ASSESSMENT REPORT			
Unique Document ID and Revision No:	ONR-OFD-AR-18-027 Revision 0	TRIM Ref:	2018/250001
Project:	Heysham 1 Reactor 2 2018 Periodic Shutdown		
Site:	Heysham 1		
Title:	Heysham 1 Reactor 2 2018 Periodic Shutdown: Structural Integrity Assessment of the Graphite Core Inspection Findings		
Nuclear Site Licence No:	60		
Licence Condition(s):	30		
ONR Assessment Rating (Mandatory): <i>(Rating should be based on licensee's original safety case submission)</i>	GREEN		
COIN Service Order:	SVC4285368

**Heysham 1 Reactor 2 2018 Periodic Shutdown – Assessment of the results of the
Graphite Core Inspections**

Assessment Report ONR-OFD-AR-18-027
Revision 0
AUGUST 2018

Figure 3: Axial crack observed in Channel W21, Layer 10.

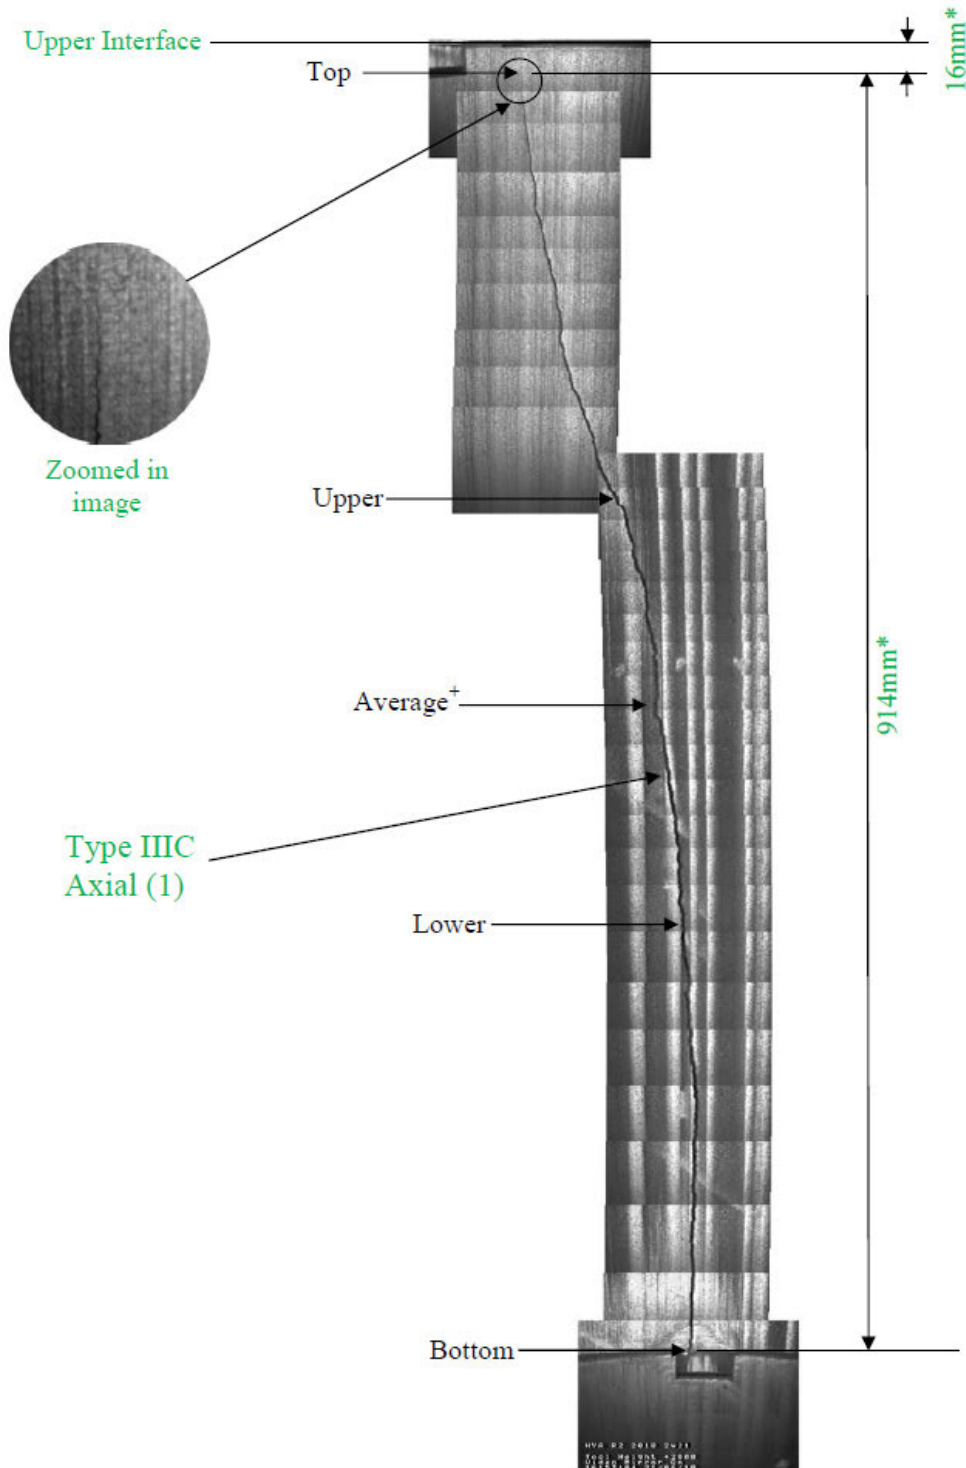
45. As Figure 3 shows, the axial crack observed in Channel W21, Layer 10, seems to originate from the end face key at the interface between layer 9 and layer 10 and follows a generally upward path with a circumferential variation from the 170° position to 120° around the bore of the brick. NGL sentenced this crack as being bore-initiated, which the small 'lipping-in' in the cardioid plot seems to suggest in the GAP sheet (Reference 16). I consider that NGL's sentencing of the crack appears to be appropriate. Although the angle of the crack appears to be unusual, I consider that this observation does not challenge the safety case assumptions and can be categorised as an axial crack.

46. Stress reversal in irradiated graphite occurs after a period of time when the dimensions of the graphite stop shrinking and begin to expand and is thus a precursor to keyway root cracking. Evidence of the onset of stress reversal would represent a challenge to the current safety case as it would undermine the safety case prediction of the date of onset. Of the channels that had been inspected at previous periodic shutdowns, none had previously contained a full axial crack, therefore no direct evidence of crack opening due to stress reversal is available. I have reviewed the inspections findings and find that the characteristics of pre-stress reversal behaviour are present, such as lipping-in of the crack at the bore surface and therefore consider that NGL' sentencing of the cracks as bore cracks appear to be reasonable.

47. Considering the low number of full height axial cracks that have been identified, the associated brick distortions, and the apparent absence of keyway root cracking, I judge that the visual inspections do not challenge to the safety case assumptions.

Figure 4: Historical channel tilt measurements at HYA R2.

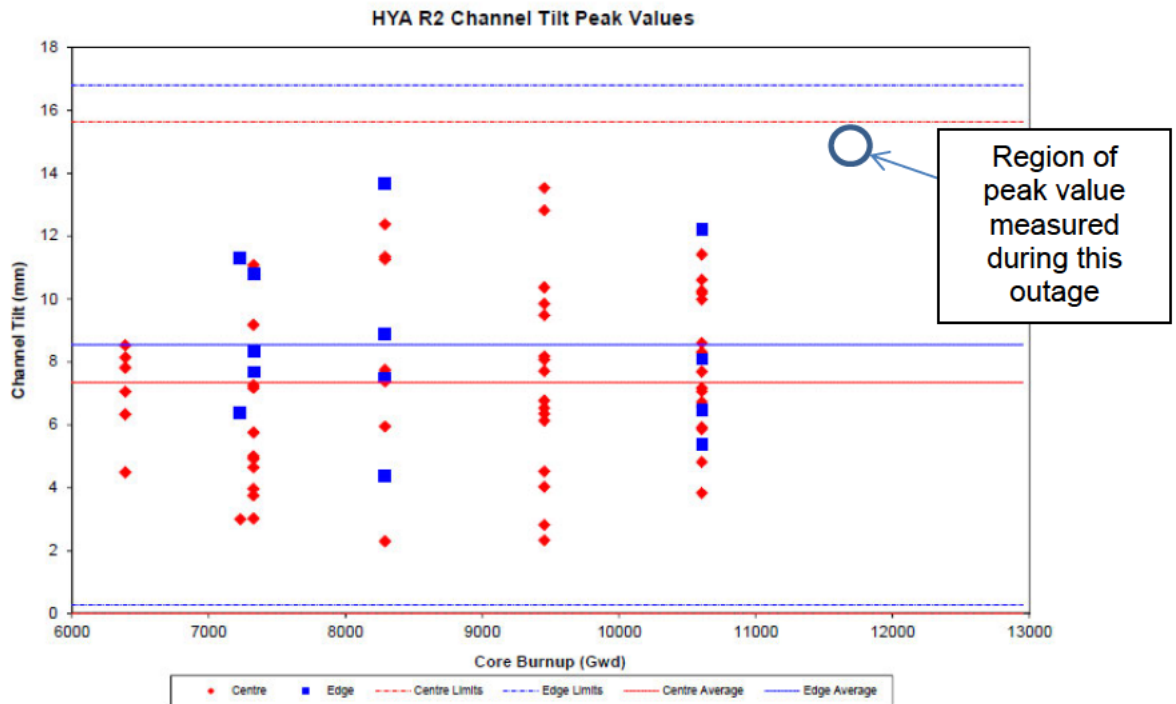
50. The channel tilt measured in Channel W21, an edge channel (Figure 1), is 15.3mm in layer 11 and 15.2mm in layer 12 (evidence 1.4.1 of Reference 4). This is the highest channel tilt yet measured at HYA and amongst the highest in the fleet (Table 5 of Reference 14). Channel W21 has no previous inspection history. NGL's view in EC 363869 is that the channel tilt measured in Channel W21 is not significant compared to the channel length of 10 meters and considered the measurements to be within expectation. NGL also considered the channel bow to be relatively small (4.2mm maximum at layer 7), which indicates that keyway disengagement is therefore unlikely to have occurred in the vicinity of the channel. Figure 4 shows the historical channel tilt measurements at HYA 2 (from Reference 14). I added a circle to this graph to show the approximate region of the maximum channel tilt measured during the current periodic shutdown for reference, i.e. 15.3mm.

51. Figure 4 shows that the latest channel tilt measurement of Channel W21 seems to be quite significant compared to similar historical measurements, although not outside expectations. Furthermore, higher channel tilts were measured at HRA. I also note that there is currently no safety case limit being applied to the maximum channel tilt value. I therefore consider that the maximum channel tilt value of 15.3mm measured for Channel W21 is unlikely to challenge the structural integrity of the core.
52. Overall, the measurements from the graphite core inspections appear to be within expectations and do not seem to challenge the assumptions of the safety case.
